PARTS & SERVICE NEWS

REF NO.	AT03109
DATE	Jun. 24, 2003

SUBJECT: REPAIR PROCEDURE OF FUEL PIPE IN FUEL TANK ON WA1200-3

PURPOSE: To introduce modification procedure to repair the fuel suction tube positioned inside the fuel tank on WA1200-3 wheel loaders

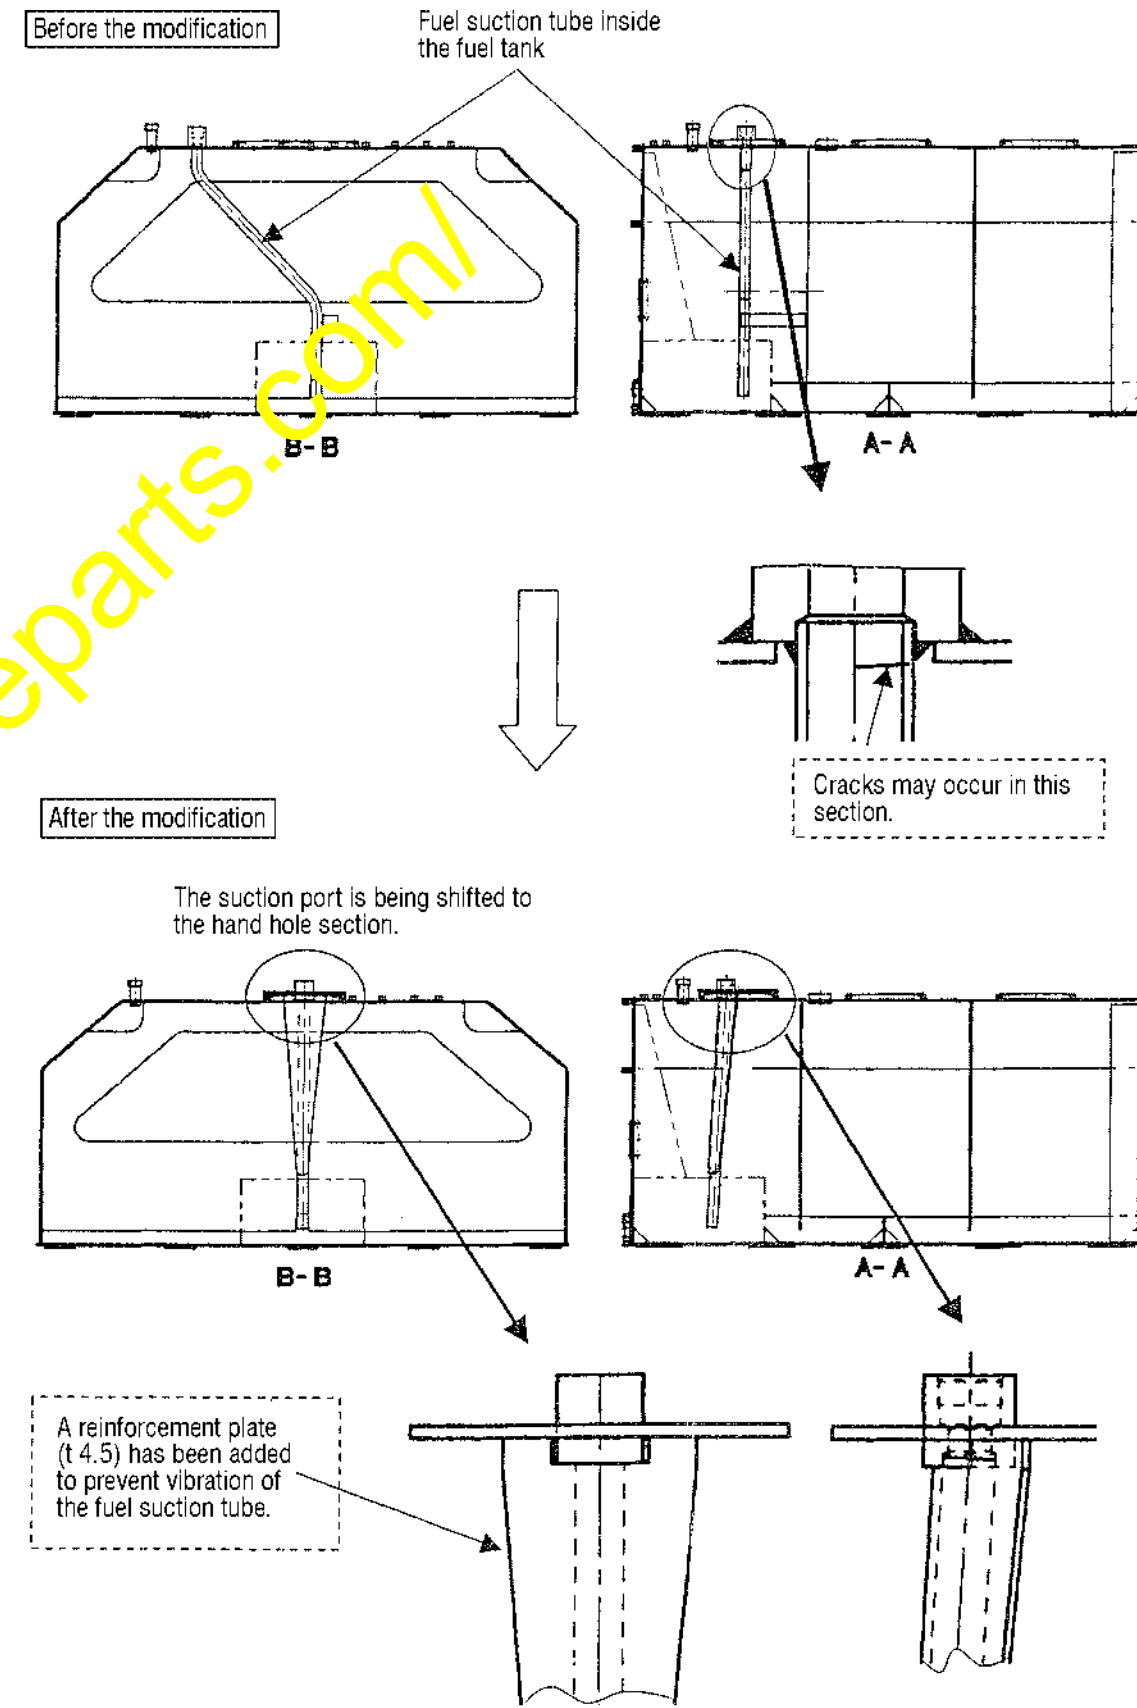
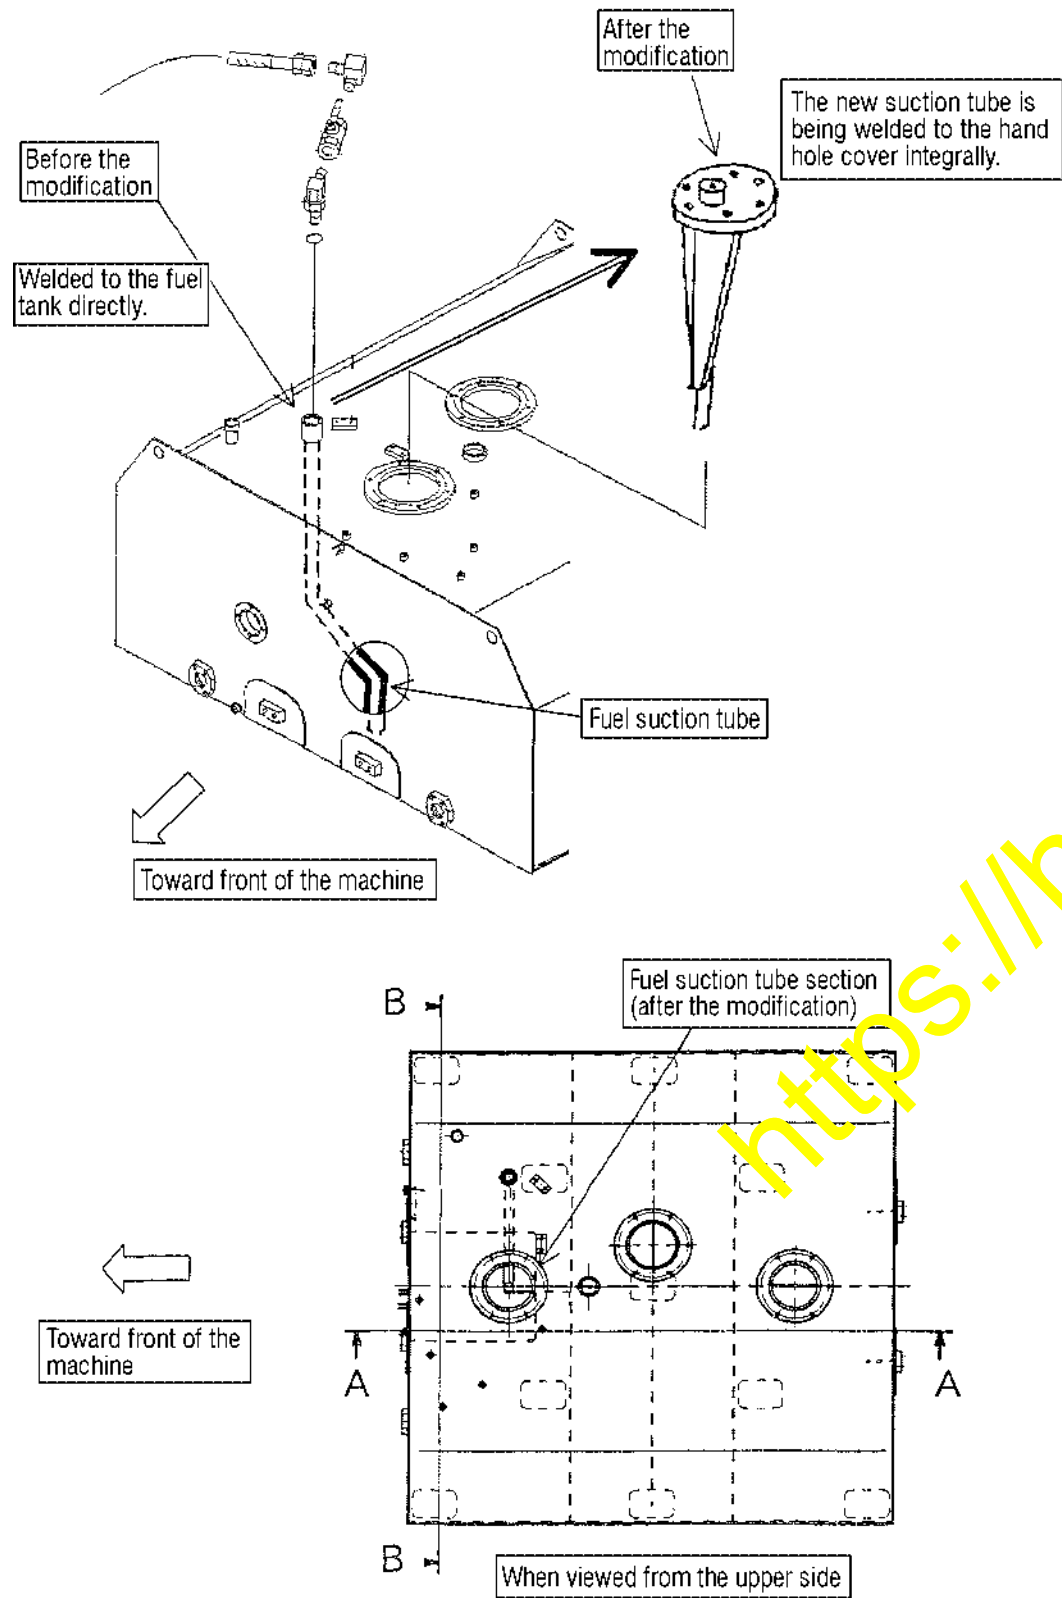
The fuel suction tube positioned inside the fuel tank is to be changed from the current type which is being welded to the fuel tank directly to a new type which is to be welded to the hand hole cover thus making it possible to change the fuel suction tube. The welded section to the hand hole cover is also being reinforced.
